RO INQUIRY REPORT NO. 50-219/72-12  
JERSEY CENTRAL POWER & LIGHT COMPANY  
OYSTER CREEK 1 - BWR  
HUMAN ERROR - FUEL BUNDLE FOUND WITH A 90° MISORIENTATION

RO INQUIRY REPORT NO. 50-219/72-11  
JERSEY CENTRAL POWER & LIGHT COMPANY  
OYSTER CREEK - BWR  
EQUIPMENT FAILURE - LOOSE BAFFLES IN TORUS

CO INQUIRY REPORT NO. 50-219/72-09  
JERSEY CENTRAL POWER & LIGHT COMPANY  
OYSTER CREEK - BWR  
EQUIPMENT DEFICIENCY - CRACKS IN SAFETY VALVE SEAT BUSHING

Safety Valve  
Seat Bushing

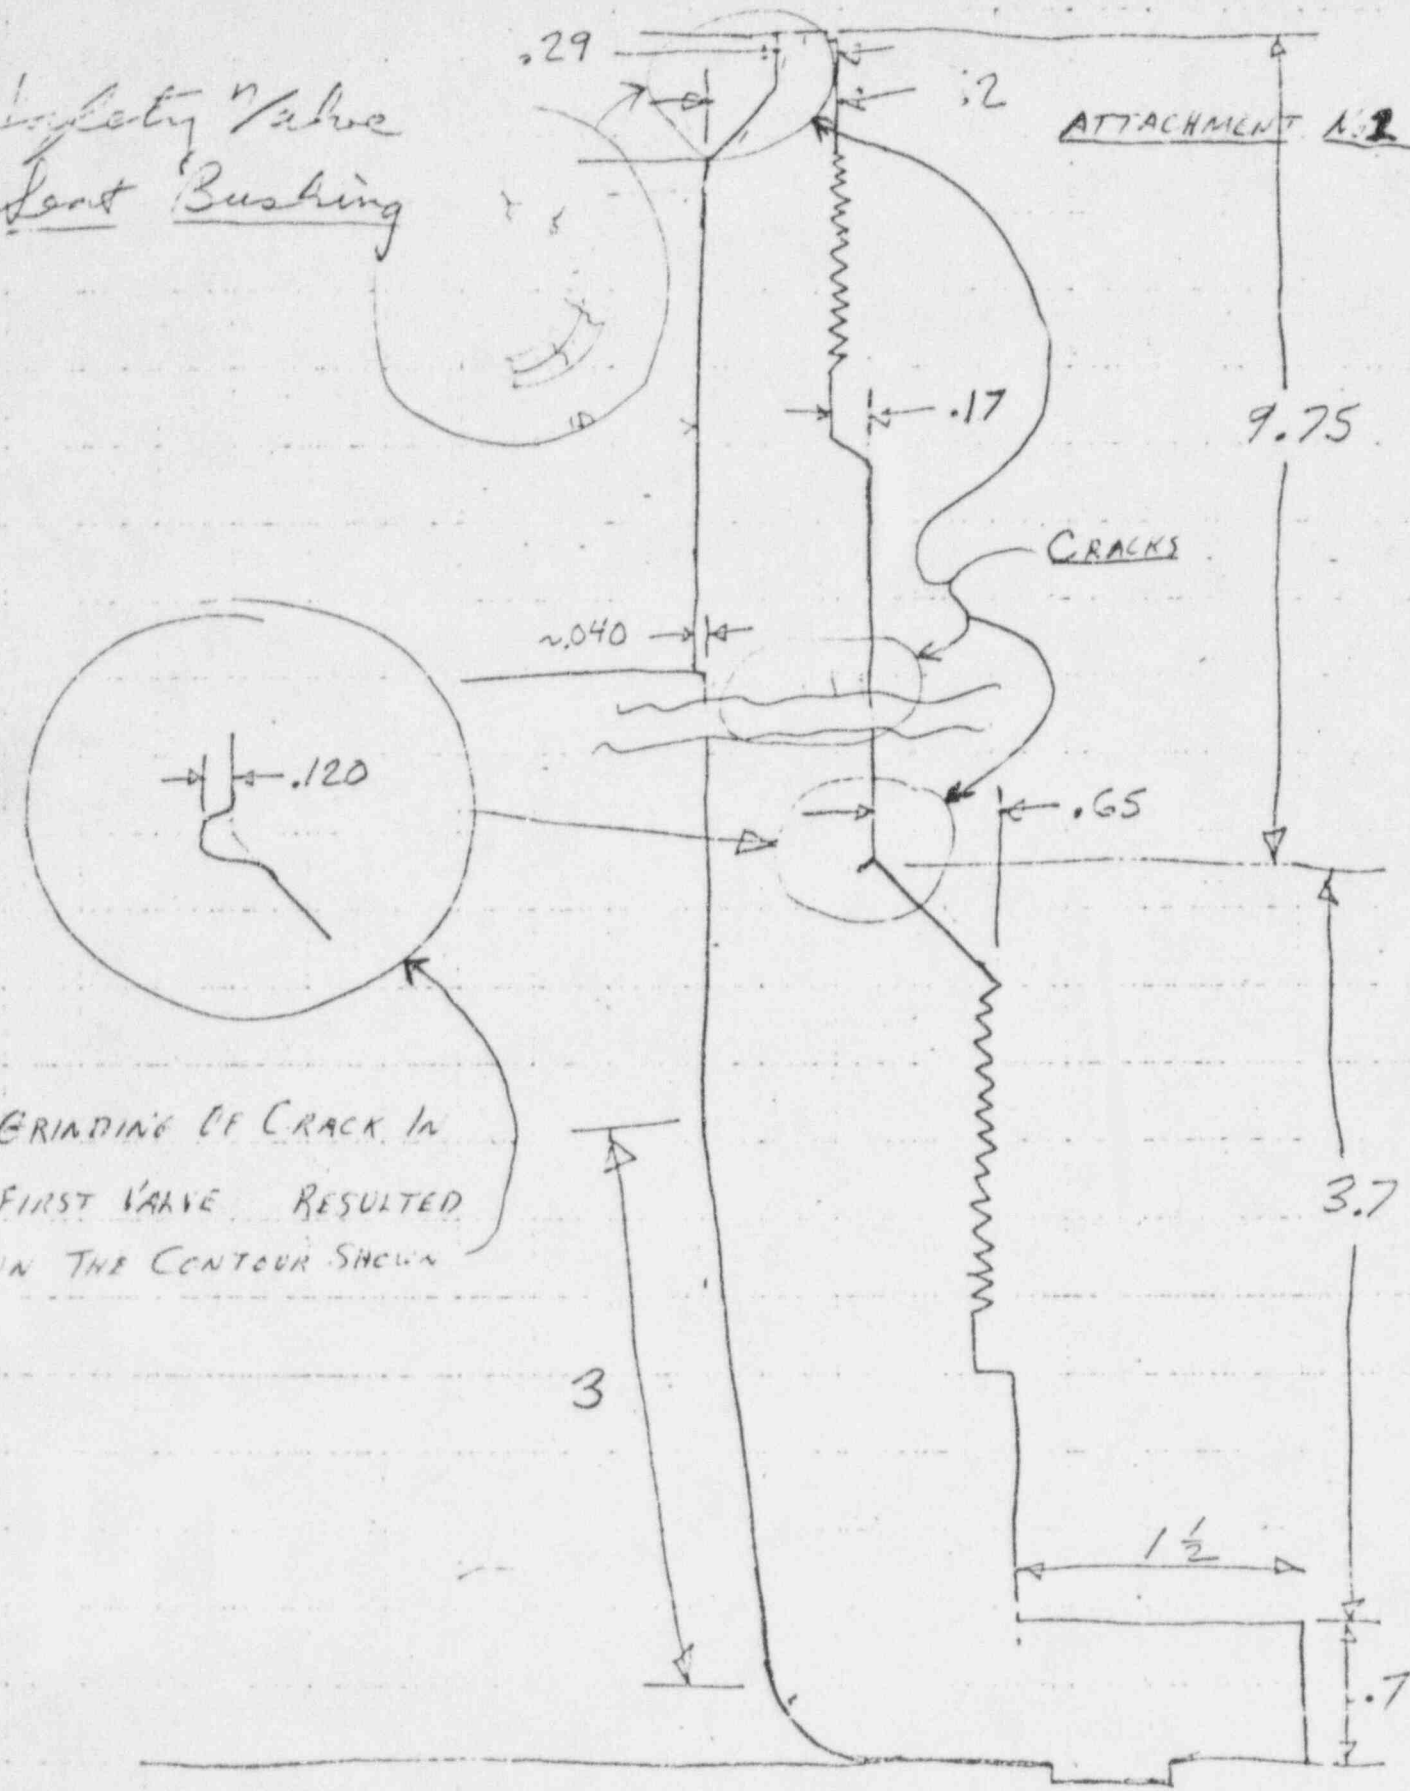
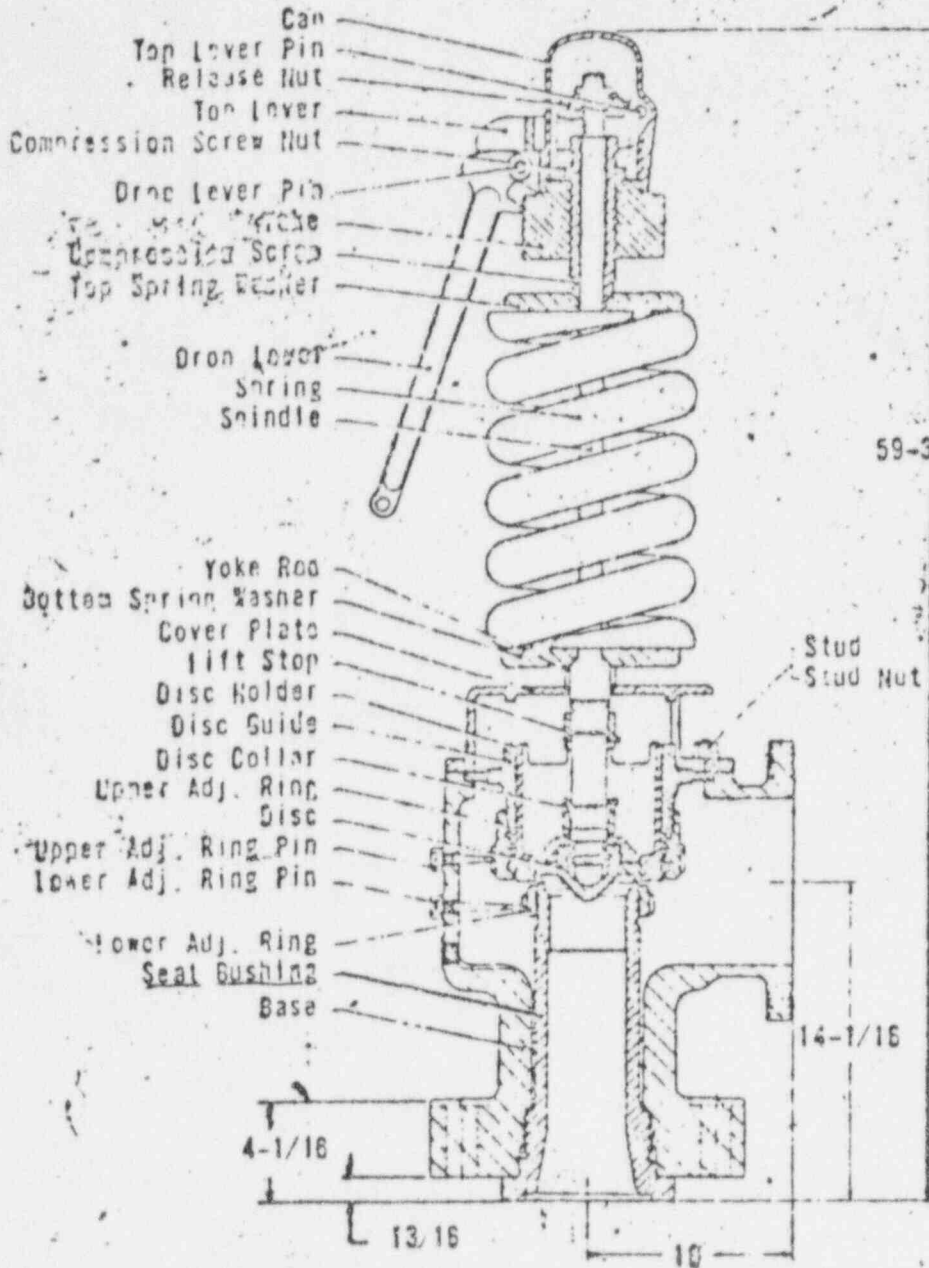
During the September - November 1971 outage, five safety valves were replaced with five clean tested spare valves. The plans were to test the five valves removed using nitrogen; however, a correlation between testing with cold nitrogen and hot steam was not available. As a result, it was necessary to send the valves to the manufacturer's shop for testing and to determine the correlation between cold nitrogen and hot steam for future testing. Efforts to decontaminate the valves to suitable levels for shipment to the manufacturer's shop (less than 2 mR/hr) were unsuccessful until the valve seat bushing was unscrewed from the valve body. When initial decontamination efforts on the seat bushing of the first valve were unsuccessful, a dye check showed radial cracks on the seat and a circumferential crack approximately 4.4 inches from the base, at a point where the wall thickness completed the transition from 1.4 inches to 0.75 inches. It was necessary to grind to a maximum depth of 0.12 inches to remove the circumferential crack (Attachment No. 1).

GRINDING OF CRACK IN  
FIRST VALVE RESULTED  
IN THE CONTOUR SHOWN

The valve seat of the second valve was shipped to General Electric, San Jose, California by air freight for metallurgical analysis, on April 20, 1972. The results are currently being evaluated by General Electric.
